RENESAS TECHNICAL UPDATE

Product Category	Application specific IC		Document No.	TN-ASP-022A/E	Rev.	1.00
Title	M66291 Usage Precautions of the Buffer memory initialization by the Control Read Buffer		Information Category	Technical Notification		
Applicable Product	USB ASSP M66291	Lot No.	Reference Document	M66291 Data Sheet (REJ03F0125)

Figure 1. Buffer clear for Control Read Buffer

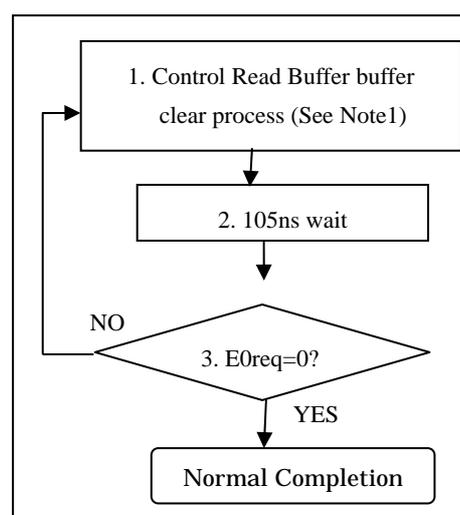
1. Phenomenon

When sending/receiving packets other than EP0 (EP1, EP2, etc.), the buffer clear process (see Note 1) is disabled when executed in the Control Read Buffer (the buffer used for control read transfers).

This phenomenon occurs when the buffer clear process (see Note 1) is executed in the Control Read Buffer during any of the following three packet transfers (during the periods described).

Repeat the Control Read Buffer buffer clear process until normal completion.

Specifically, use the clear process as described below (also see Fig. 1).

1. Execute Control Read Buffer buffer clear process (see Note 1).

2. Wait 105ns or more after Step 1.

3. Confirm E0req. Repeat Steps 1 and 2 until

E0req is "0" (normal completion)

Note 1: When ISEL = 1, set EP0_BCLR = 1.
